AGENDA ITEM 13
PLANNING & DEVELOPMENT SERVICE
PLANNING DIVISION
455 Mountain Village Blvd.
Mountain Village, CO 81435
(970) 728-1392

TO: Mountain Village Design Review Board

RE: Consideration of a Design Review: Final Architecture Review for a new Single-Family Detached Condominium on Lot 165 - Unit 7, 170 Cortina Drive, pursuant to CDC Section 17.4.11.

C1-0.4
DRB DRIVE PLAN AND PROFILE

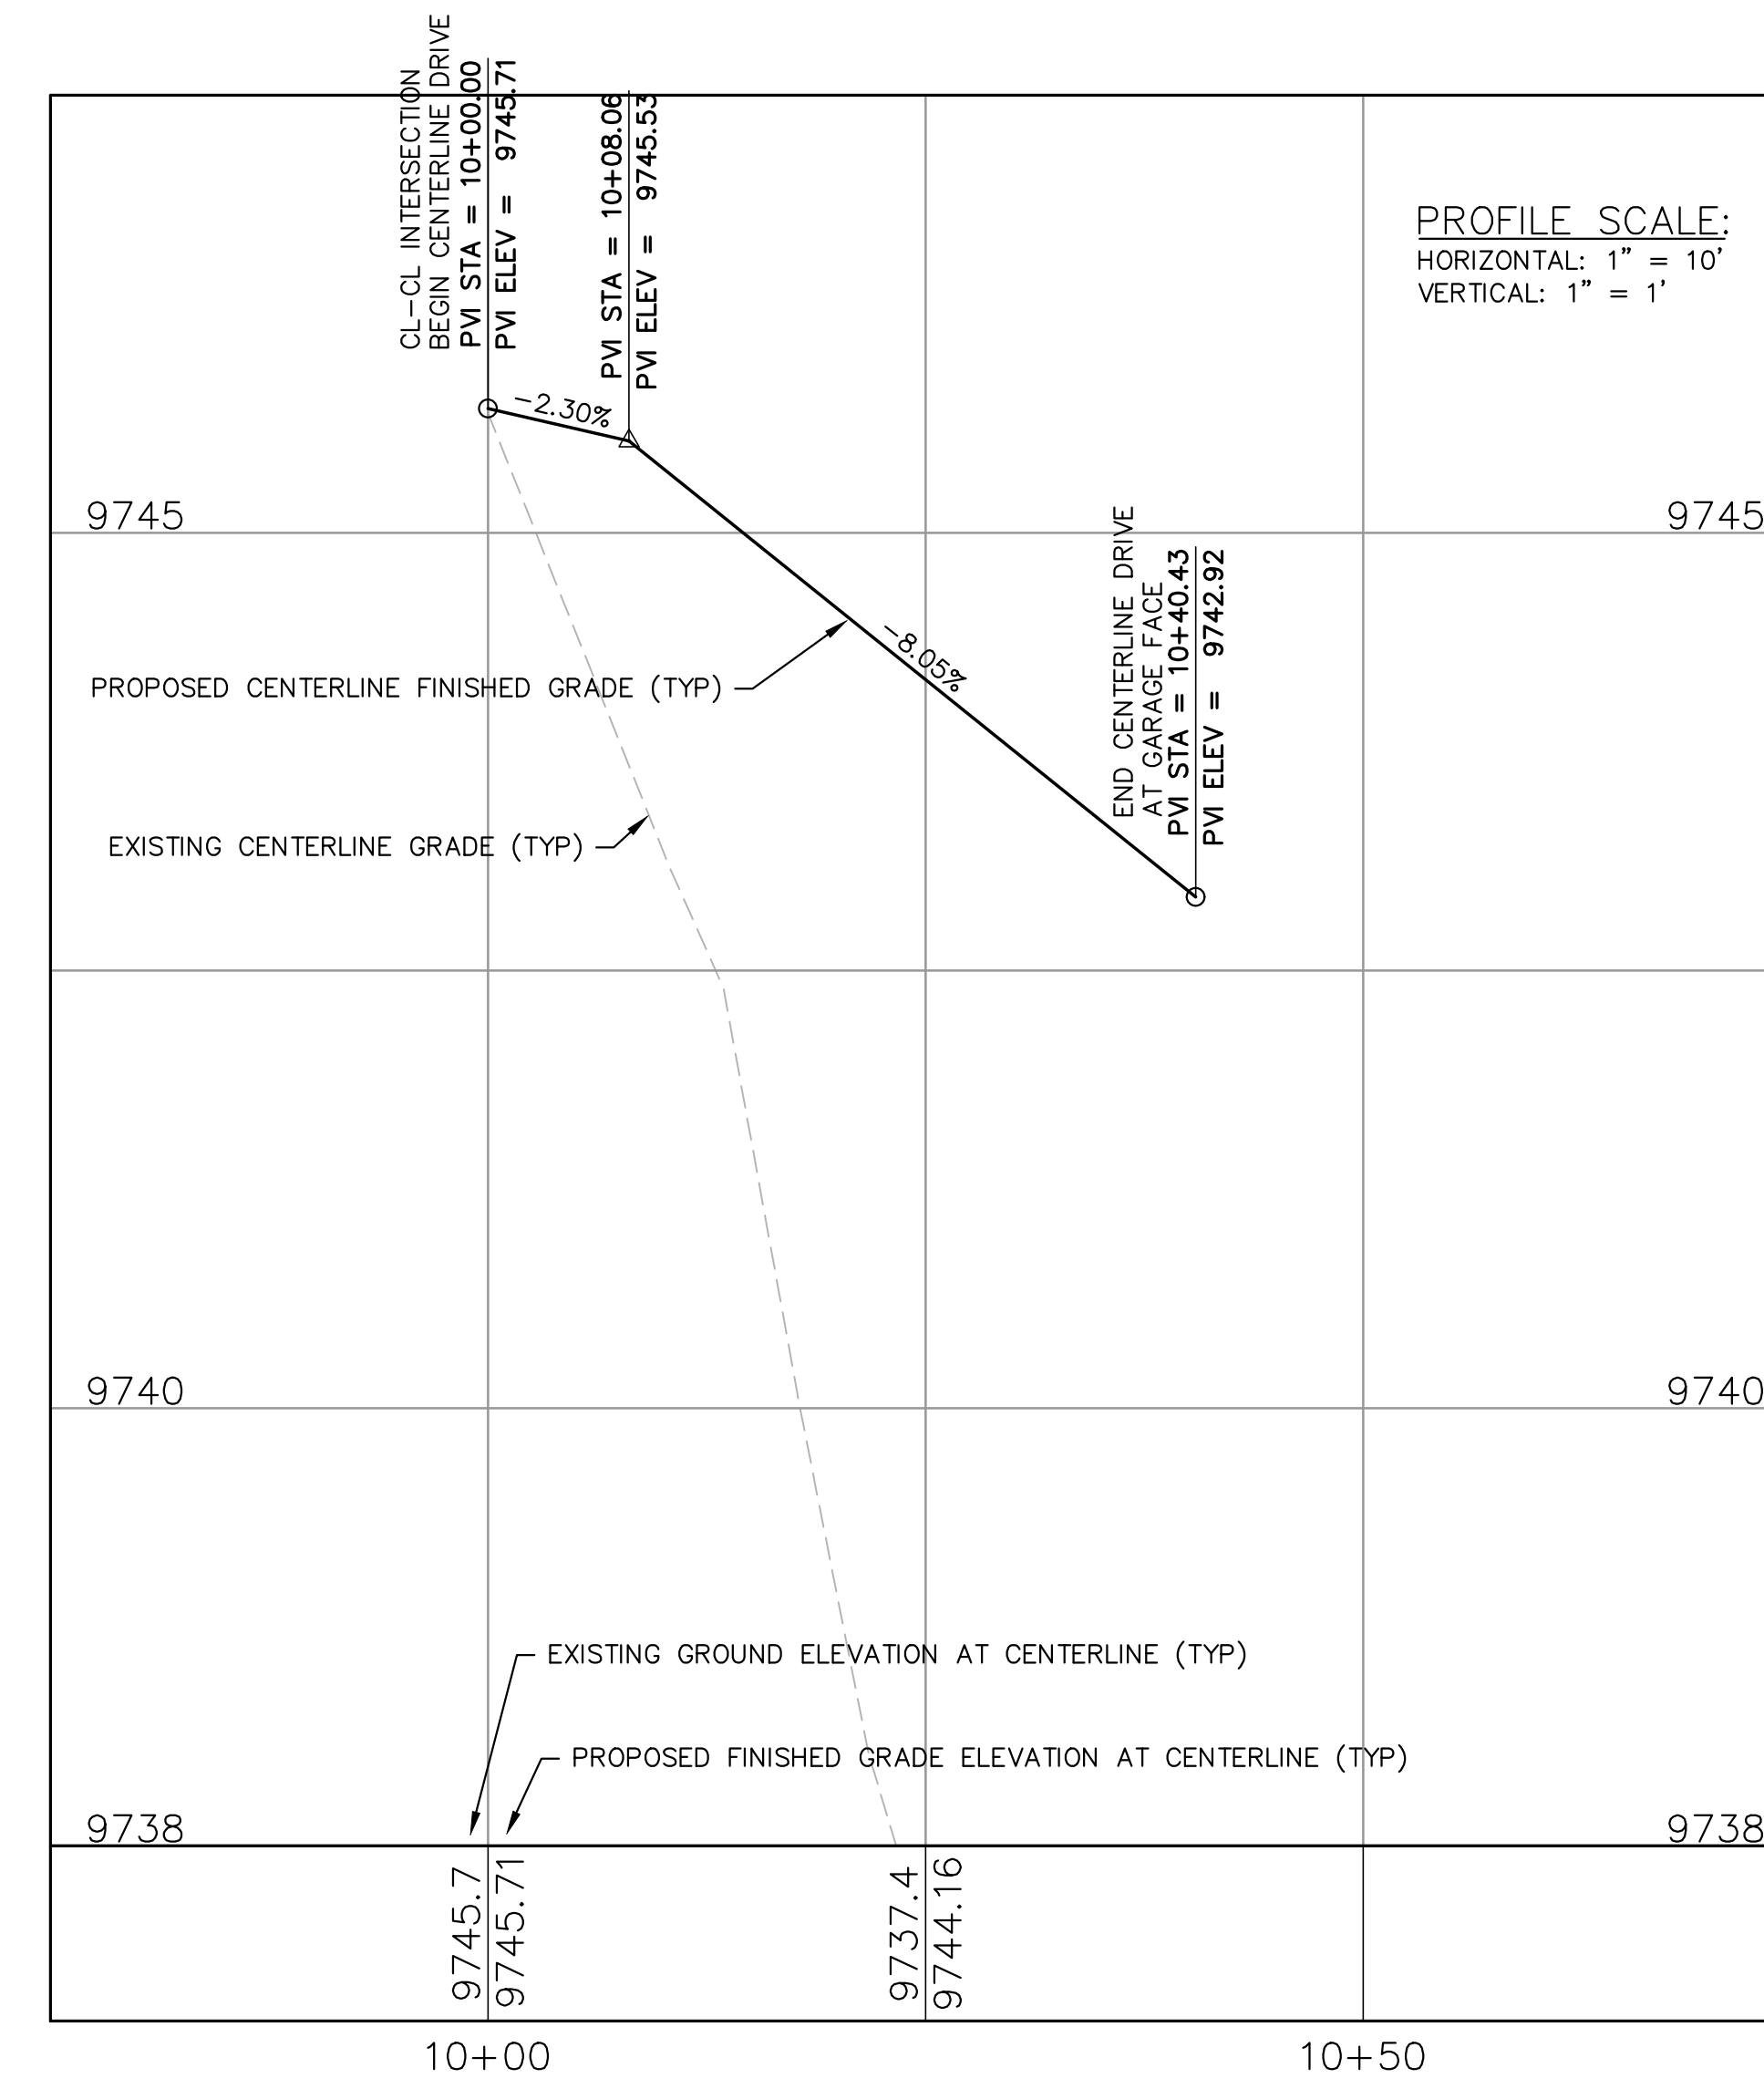
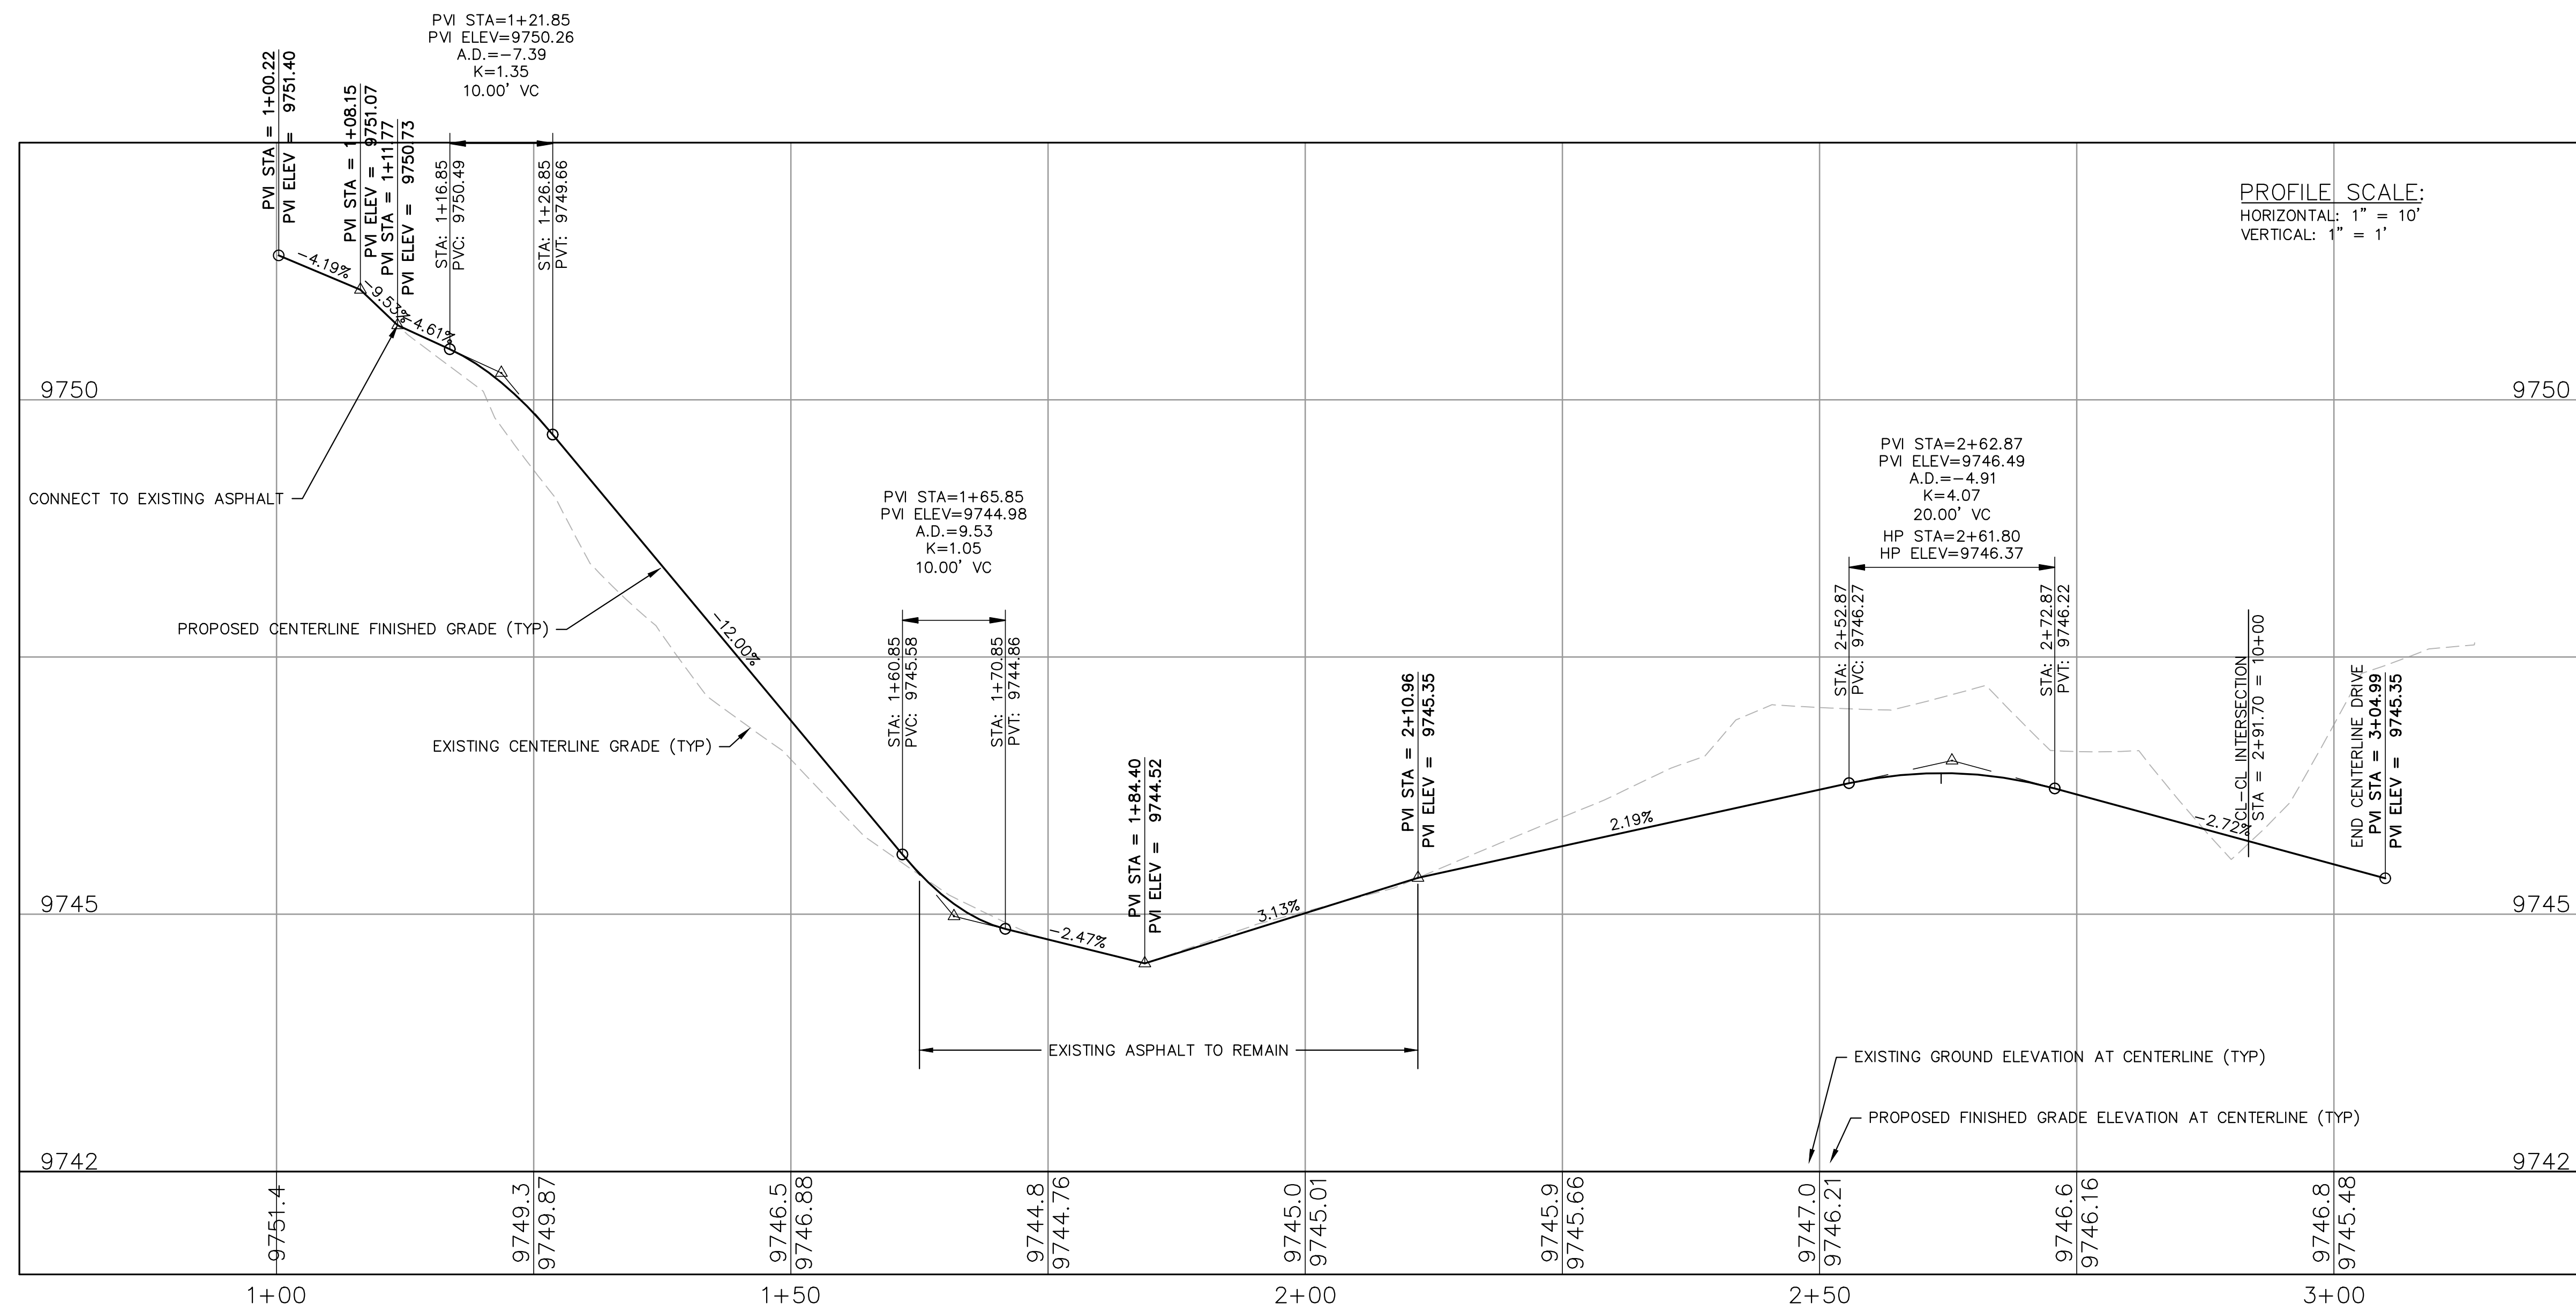
Staff: Because of the location of the home and the nature of the shared drive for Units 6, 7, and 8 – the actual driveway area for Unit 7 is quite small. Based on the Initial Review, the applicant has provided some additional driveway grade plans that demonstrate the grades of both the access easement as well as the actual driveway. There are portions of the access easement shown at approximately 12% grade but the portion of the road in that location is pre-existing.
